RE: Proxim Corporation

FCC ID: HZB-4000LR

After a review of the submitted information, I have a few comments on the above referenced Application.

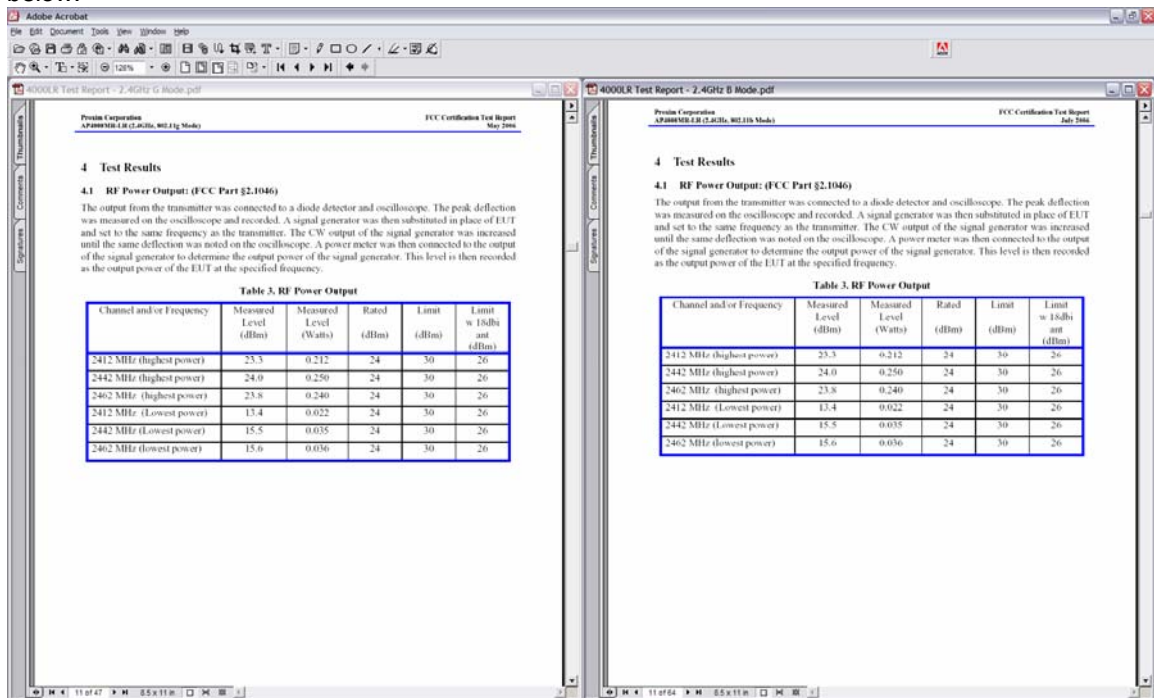
- 1) Previous response to 3 appears inconsistent with 2 most recent 802.11b/g reports provided. See below:
